Determination 2025/017

An authority's decision to grant a building consent under section 72

11 Maruia Place, Te Puna, Tauranga

Figure 1: Cross section of proposed building sites and sloping topography

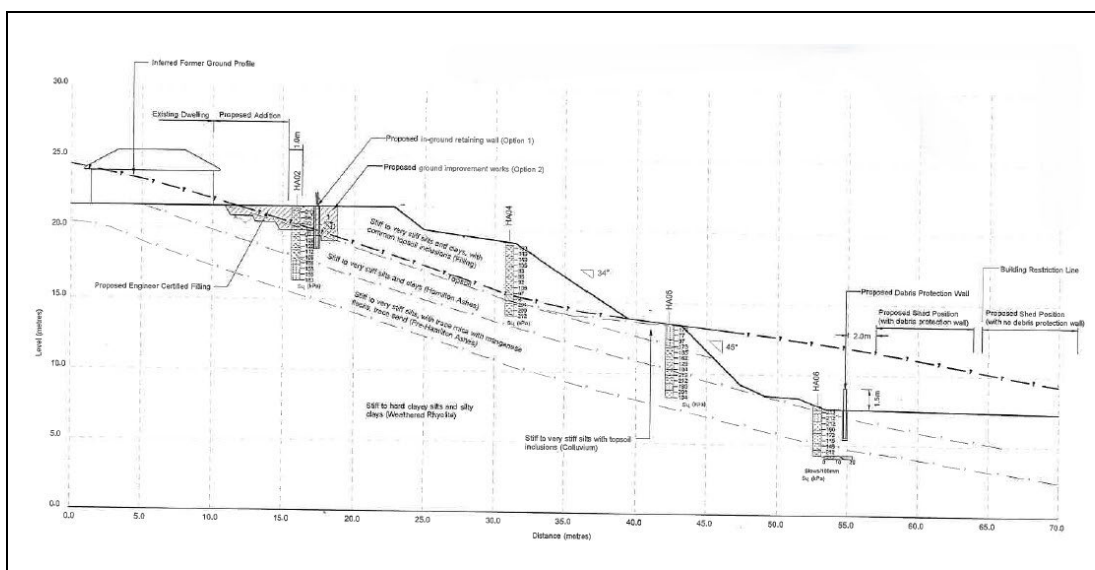
2.11. The report includes a site plan, and cross section of the proposed site and the slope. These drawings show an area of fill (“the pre-existing fill”) which appears to have been placed directly over the former ground. It is present from the perimeter of the existing dwelling, extending about 12 metres to the top of the slope, and then downslope a further 16 metres approximately. From there, the remaining slope is a cut made by earthworks, spanning about 10 metres, with several layers of differing subsoils exposed.

2.12. Both drawings show the dwelling additions (as proposed at that time) sited partially over the pre-existing fill (by around 4 metres).¹² The northern perimeter of those additions is shown approximately 8 metres away from the top of the slope. The shed (as proposed at that time) is shown approximately 3.5 metres away from the pre-existing batter at the bottom of the slope.
